S U B M I S S I O N : S Y M O N S
a written submission by way of further objection to DA 2019/1463

RE:
DA 2019/1463
Address: 95 Gurney Cr., Seaforth

WRITTEN SUBMISSION: LETTER OF OBJECTION
Submission - Symons

This document is a written submission by way of further objection to **DA 2019/1463** lodged under Section 4.15 of the EPAA 1979 [the EPA Act]

Appendix A: More Skillful Design

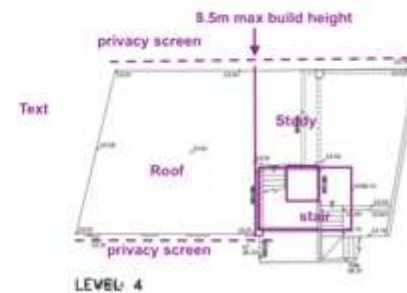
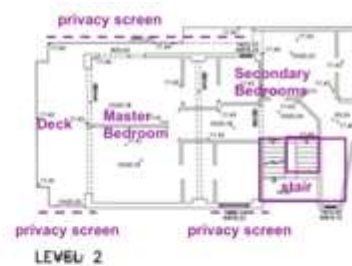
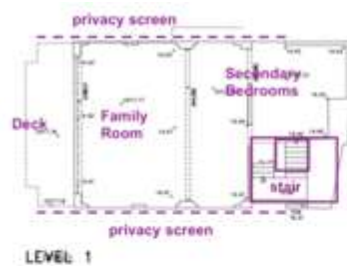
Large undercroft areas are evident at Level 1, that add to the bulk. In our more skilful design [Appendix A], Level 1 is used for an additional family room and secondary bedrooms.

In this objection we have clearly showed that the same amount of floor space and amenity can be achieved while reducing the impact. The proposals do not comply with planning controls, and the impact is due to the non-complying element of the proposal.

Plans showing a building envelope that delivers a general arrangement that provides a New Residence consisting 4/5 Bedroom + Study/Office + 3 independent Living Spaces + Pool.
